UNITED STATES PATENT AND TRADEMARK OFFICE

APPLICATION NO.	FILING DATE	FIRST NAMED INVENTOR	ATTORNEY DOCKET NO.	CONFIRMATION NO.
09/849,342	05/07/2001	David M. Britz	3493.00073	1125

Office Action Summary

FIG.2

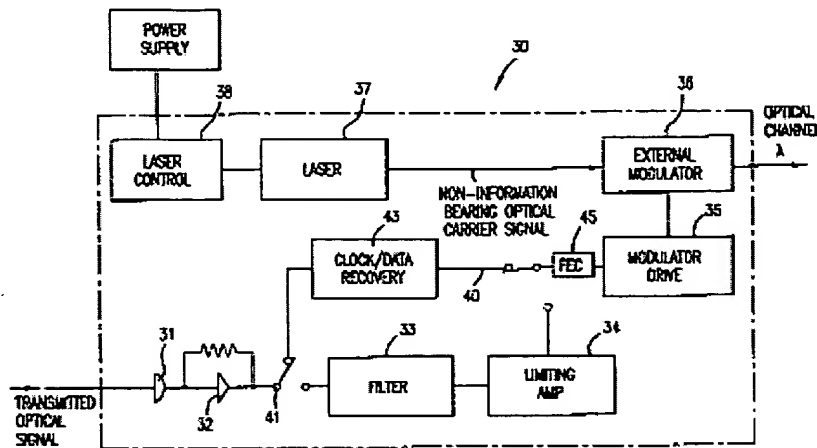
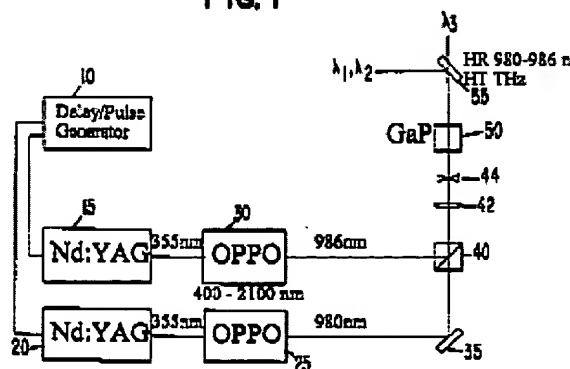
Claims 1-15 are rejected under 35 U.S.C. 103(a) as being unpatentable over Alexander et al (USPNO. 6,233,077) in view of Herman et al (USPNO. 6,144,679)

Alexander et al disclose all the claimed subject structures except for a telescope as claimed. Alexander further teaches the use an FEC encoder (as claimed in claim 6) in column 6 of Alexander et al.

The use of telescope and/or lenses which are substitutes for telescope is very elementary teachings in this optical art as is shown in Herman et al. Numerals 42 & 44 are telescope mentioned in figure 1 of the reference.

It would have been obvious to one having ordinary skill in the art at the time the invention was made to utilize such telescope/lenses of the device of Herman et al in Alexander et al which would provide a free space wavelength duplexed optical communication link that is reduces the effects of fading since, with both device being directed to a common use in the same environment, there is an implies suggestion for applying the teachings of one to the other. That is, the skilled worker who is presumed to have knowledge of the prior art, with these two references (Alexander et al in view of Herman et al) before him, would immediately recognize the desirability of employing the telescope teachings of Herman et al to the device of Alexander et al, as claimed.
